A green solvent enables precursor phase engineering of stable formamidinium lead triiodide perovskite solar cells

Corresponding Author: Professor Henry Snaith

This manuscript has been previously reviewed at another journal. This document only contains reviewer comments, rebuttal and decision letters for versions considered at Nature Communications.

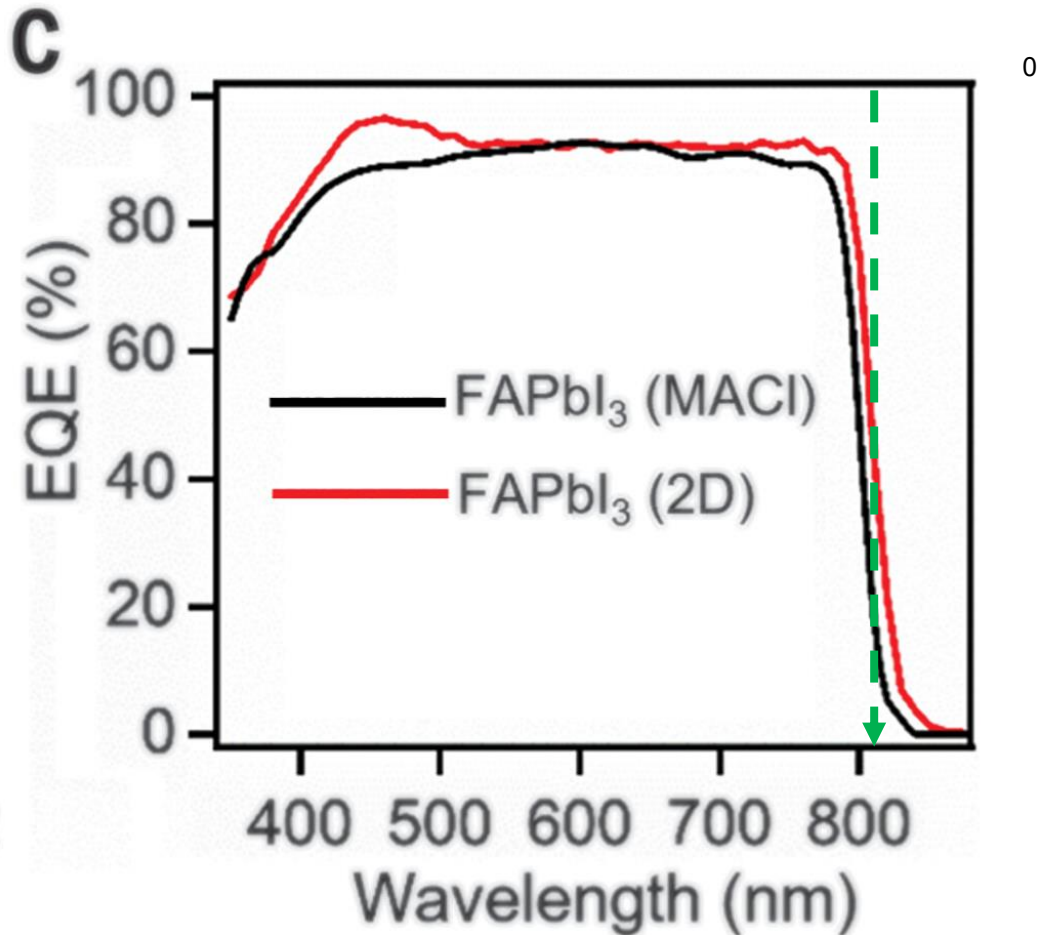
1. Given the recent work DOI: [10.1126/science.abq699](https://doi.org/10.1126/science.abq699), which shows a clear 1.48 eV band edge in the absorbance and ~1.49 eV step change in the EQE, which is still lower or equal to 1.5 eV compared to this work with a band-gap of 1.53 eV. What do the authors think causes this discrepancy if the films are indeed pure? Could it be that the films are quasi-2D with with undetectable amount of BA? Or could it be that the degree of distortions is larger, which then increases the bandgap ?

- We are grateful to the Reviewer for their positive assessment of our work, and for the consideration of this work particularly in the context of the recent study from Mohite and co-workers. Although the Reviewer did not highlight the similarities explicitly, we would like to take the opportunity to highlight that our work contains substantial novelty over that of Mohite and co-workers, in particular the development of our green solvent system, a fully sequential processing route, the extensive characterisation of the precursor phase-engineered growth mechanism (added in previous rounds of review), and the in-depth study of the origin of stability enhancement imbued into our thin film FAPbI₃ material by this growth process. Furthermore, we show proper statistics from our stability measurements, rather than data for a single solar cell.

- As we believe the Reviewer has seen, we have discussed in substantial detail the variability in the reports of perovskite semiconductor bandgaps, in particular those for FAPbI₃. In brief, this variability comes as a result of experimental discrepancies in bandgap calculations as applied by different authors and variability in the perovskite material (thin film thickness, single crystals, etc.). The most relevant band gap for PV cells is the so called “PV band gap” which can be derived by taking the differential of the EQE spectrum and noting the peak of this differential. This corresponds to the steepest part of the EQE spectrum. This PV gap most closely represents a hypothetical step-function band gap, which is often used for calculating detailed balance voltage and efficiency limits. I direct the reviewer to Nayak et al. Nature Review Materials 2018 for a full discussion on this topic. Unfortunately, despite this being pretty well recognised by the field now, Mohite et al. used the Tauc analysis to define their band gap, which usually gives a slightly different band gap than the PV gap, where the latter depends upon the thickness of the absorber layer and the optical properties of the entire cell. The onset of the EQE is also not the appropriate energy to identify as the band gap for a PV cell. Moreover, it appears that Mohite et al. did not take into account thin film reflectance when calculating the spectrally-resolved absorption coefficient, $\alpha(\lambda)$, of their thin films. This can lead to non-zero sub-bandgap absorption coefficients, which in turn result in an underestimation of the semiconductor bandgap. Noting further, for Tauc analysis $(\alpha \cdot h \cdot f)^2$ (h = Planck's constant, f = frequency) should be plotted on a linear scale against the energy, in eV. A linear region near the zero line should then be fitted, and the Tauc bandgap defined as the intersect of this line with the x-axis. For reasons that are not clear, probably due to excessive light scattering, Mohite and co-workers have decided to plot their graphs on a log-linear scale, and taken the intercept of a linear line of the higher energy and lower energy sections of the graph to identify the Tauc gap. This is highly unusual so we can not comment on the accuracy of their reported “band gap”, but it does not appear to be a Tauc bandgap.

- Falling short of extracting Mohite et al.'s data and analysing it, we have copied their reported EQE spectrum below, and inserted a dashed green arrow at approximately the steepest part of the EQE spectrum, which intercepts the x-axis somewhere between 810 and 820nm. This corresponds to a PV band gap of 1.53 to 1.51 eV.
